# VALUE ENGINEERING STUDY

Project # CSSTP-0007-00(319) PI No. 0007319

SR 347/Lanier Islands Parkway from  
Lake Lanier to McEver Rd  
Hall County, Georgia

09 May 2013

# ORIGINAL DESIGN SKETCH/DETAIL

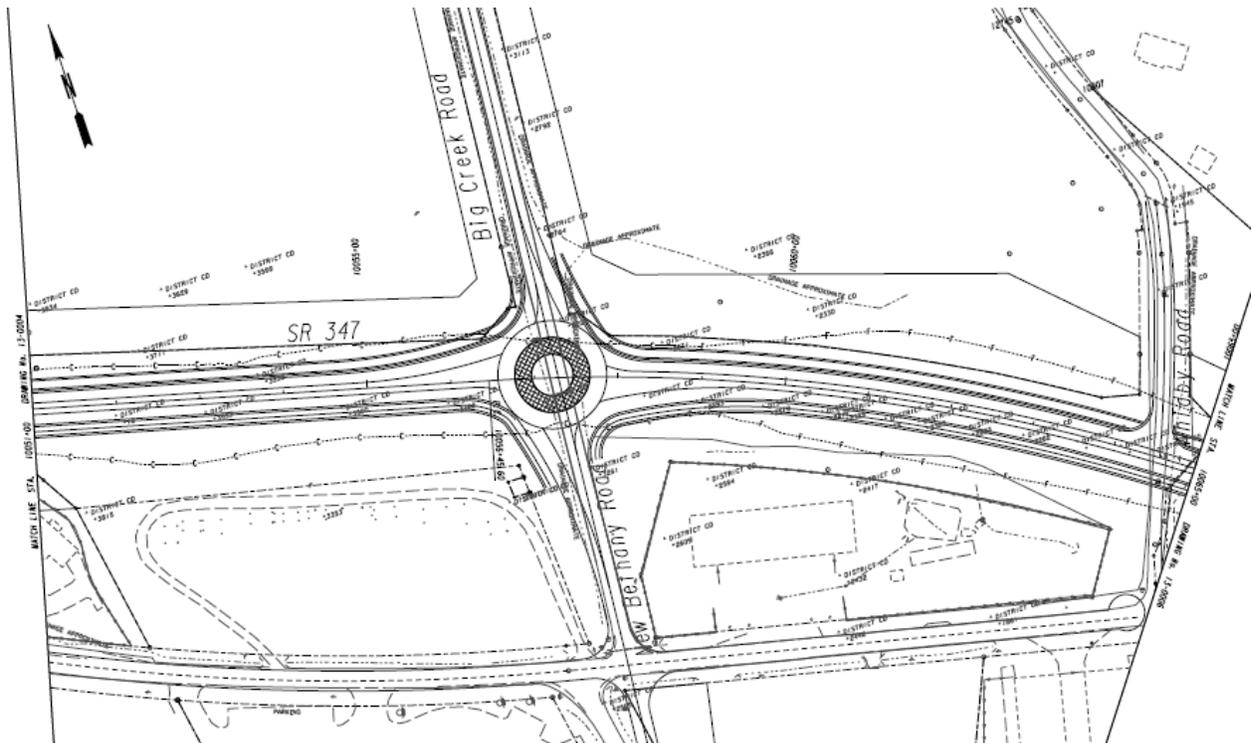
**ORIGINAL DESIGN:** The current project design has a single lane roundabout at the intersection of Big Creek Road / New Bethany Road and relocated SR 347.

**PROPOSED CHANGE:** It is proposed to eliminate the roundabout and develop a four leg intersection to be a two-way stop controlled intersection with a stop condition on the minor roadways as discussed as Alternate 1 in the project Concept Report.

**JUSTIFICATION:** The design of a four leg intersection is Alternate 1 in the Concept Report. The rationale included in the Concept report states the alternate satisfies the goals outlined in the Project Justification Statement. The report states this alternate will provide an efficient means to reduce time as well as reduce cost to property, right-of-way, total cost and construction time in the short term.

Proposed Change: Change Intersection at Big Creek Rd/New Bethany Rd from Roundabout to Stop Controlled

**PROPOSED CHANGE SKETCH/DETAIL**

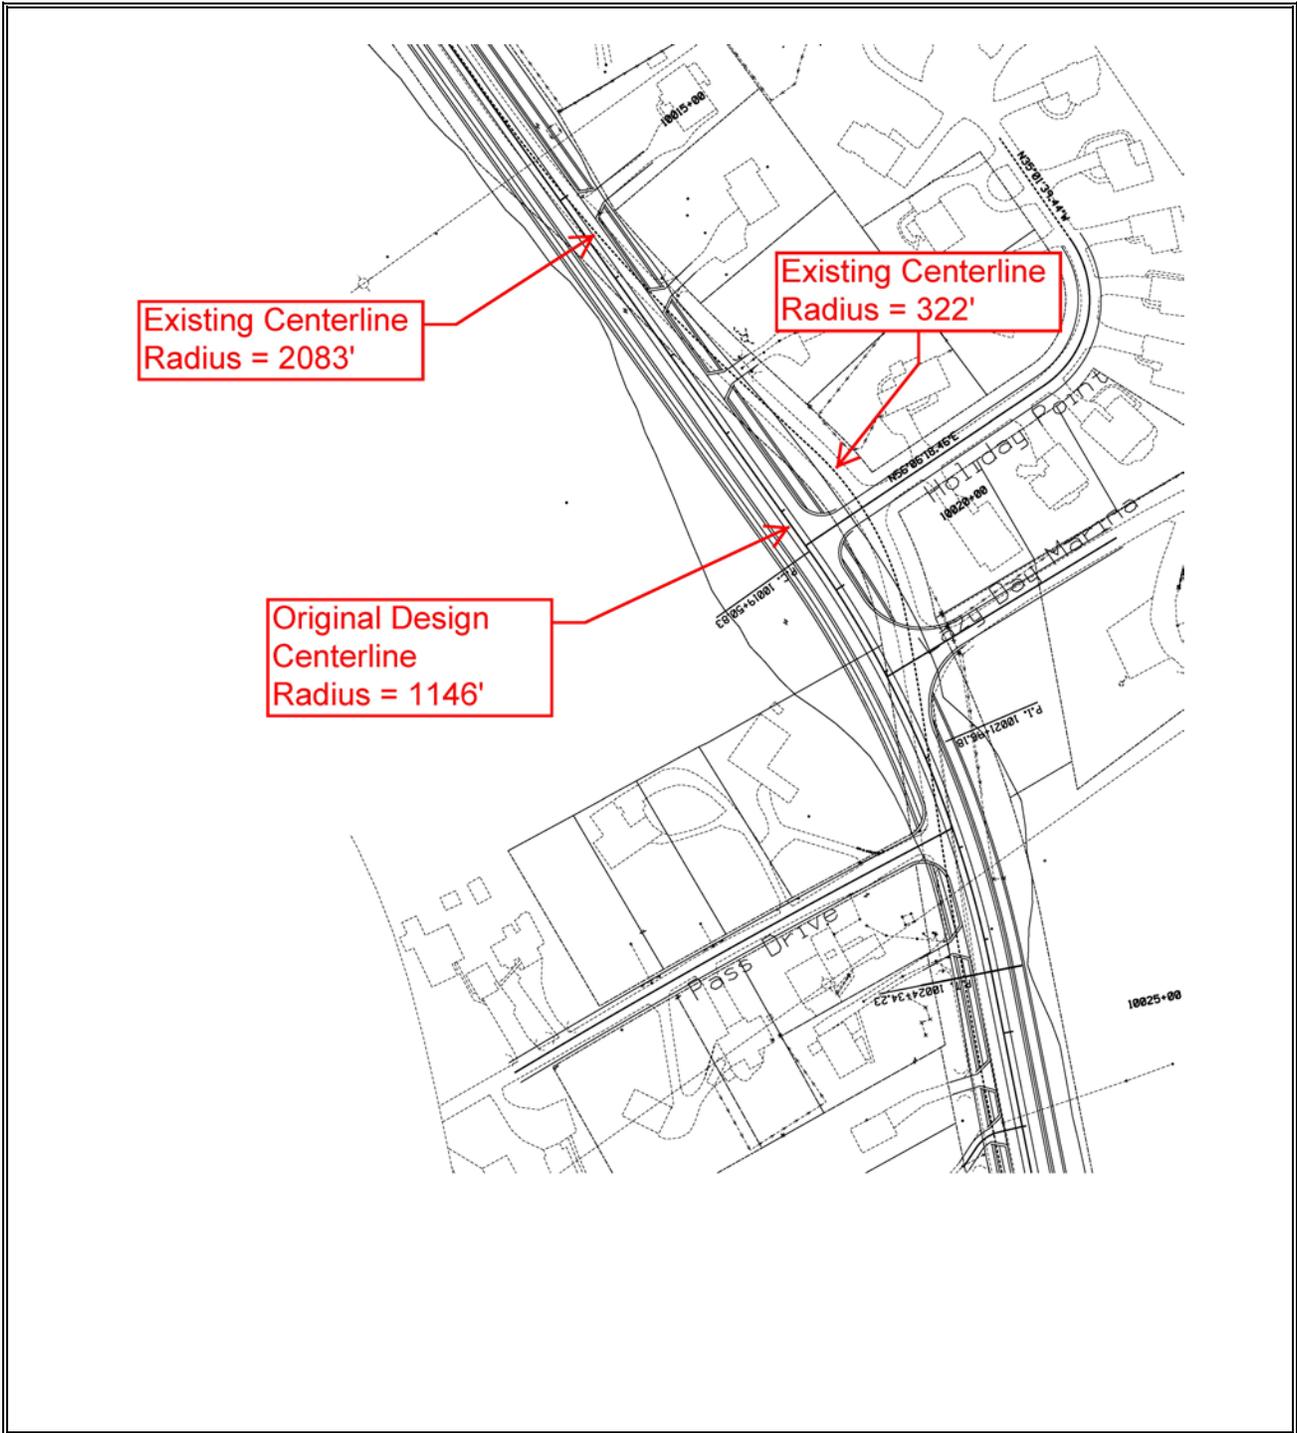
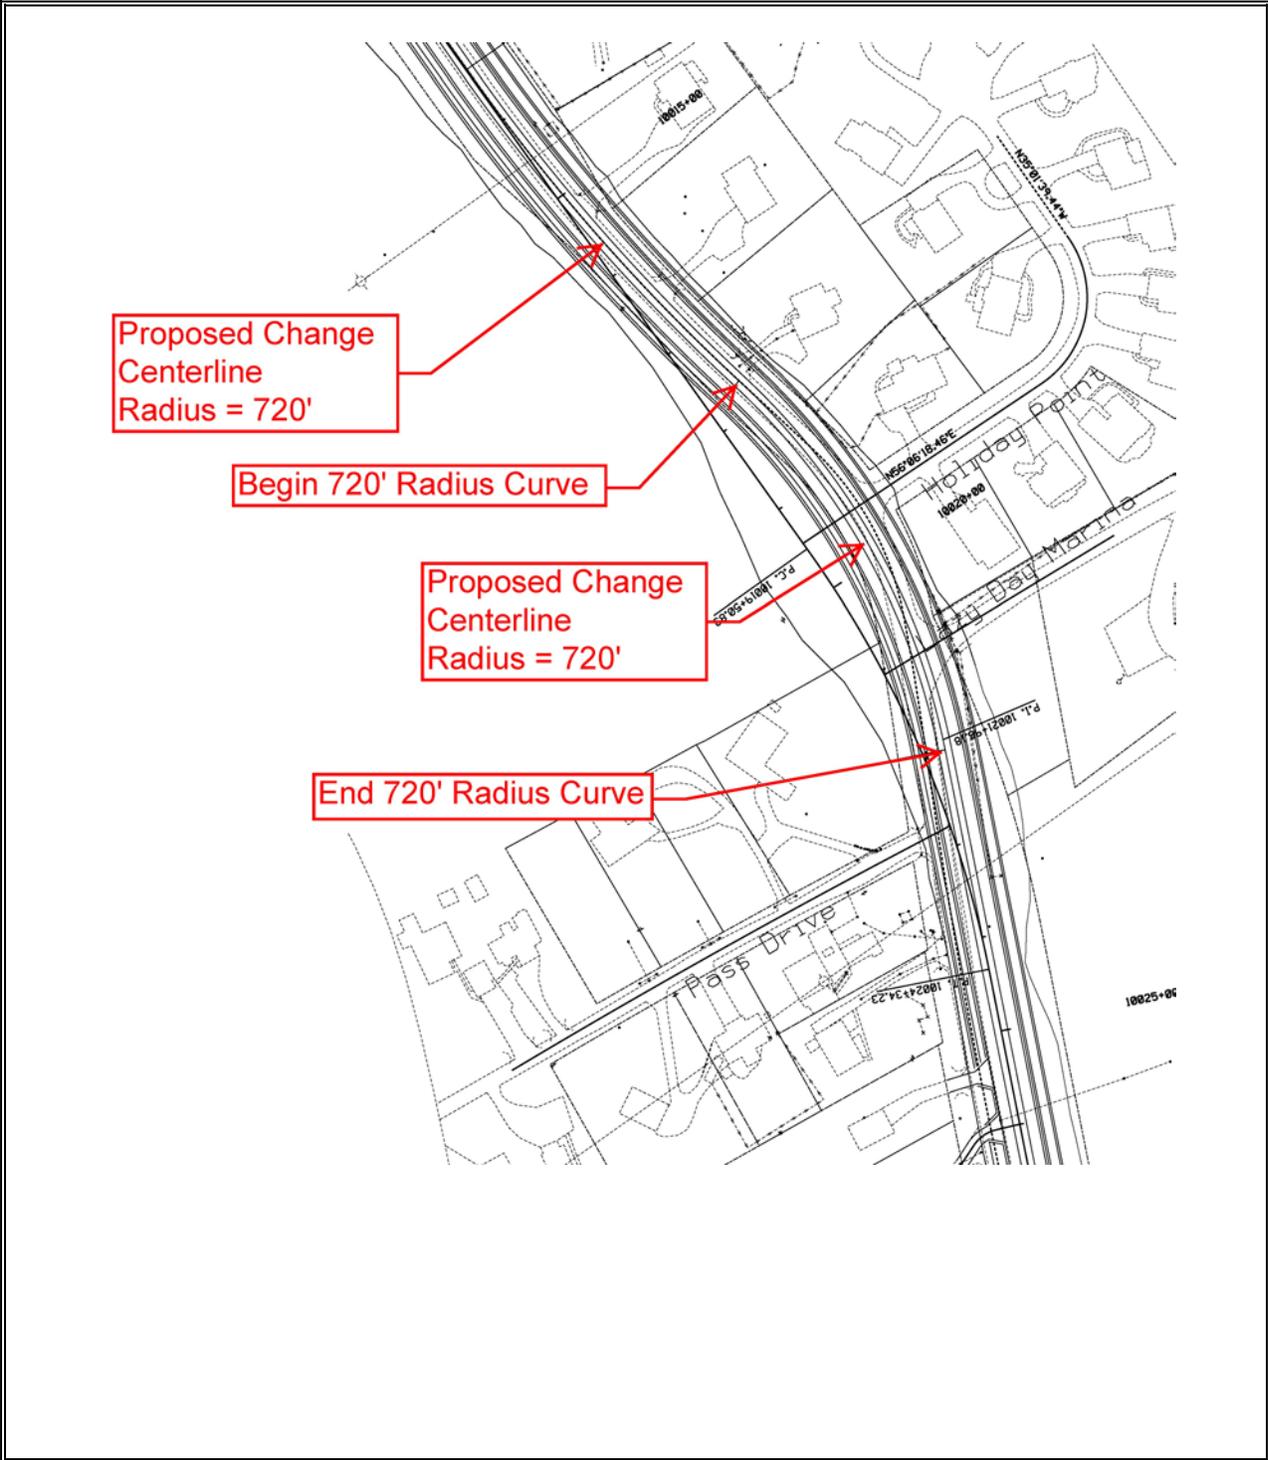
**PROPOSED CHANGE:** The proposed change would maintain the existing 2,083-foot radius curve and replace the existing 322-foot radius curve with radius of 720 feet. This is just slightly greater than the required minimum of 711 feet for the design speed of 45 mph.

# PROPOSED CHANGE SKETCH/DETAIL

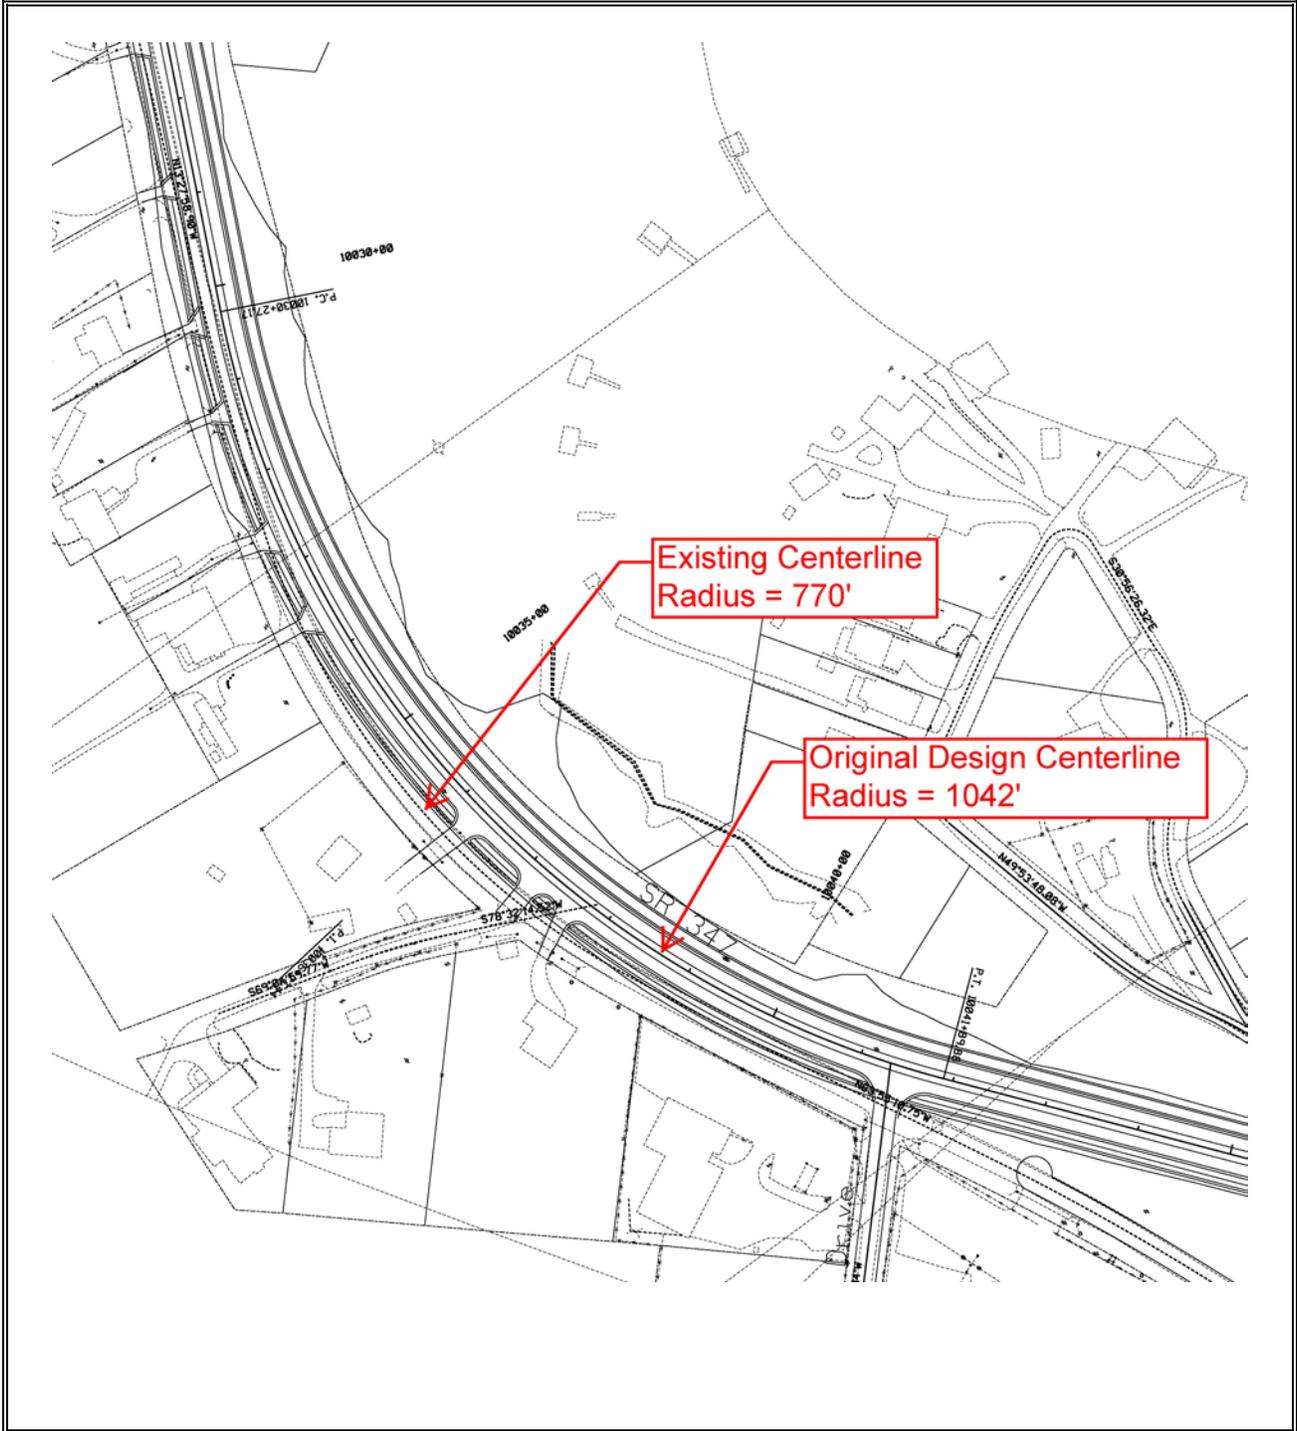
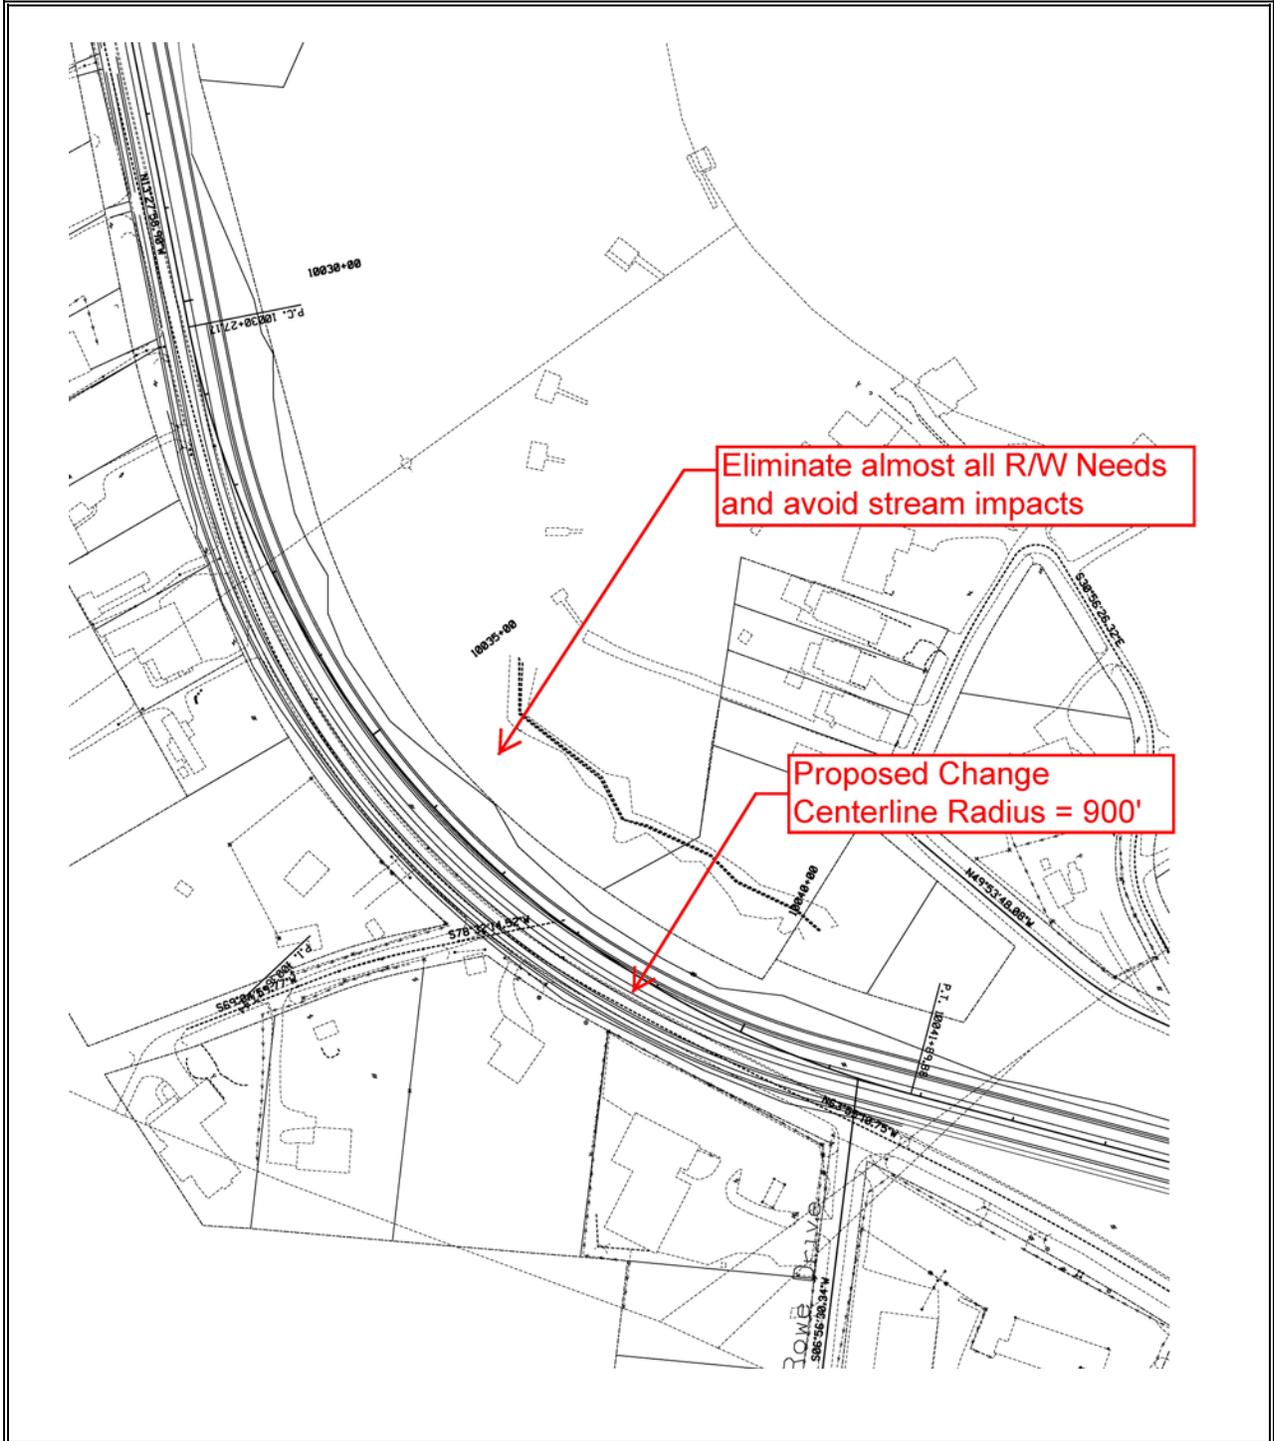
**PROPOSED CHANGE:** The proposed change is to utilize a horizontal curve with a radius of 900 feet. This is more than the required minimum of 711 feet for the design speed of 45 mph; however it allows the improvements to occur within the existing right-of-way.
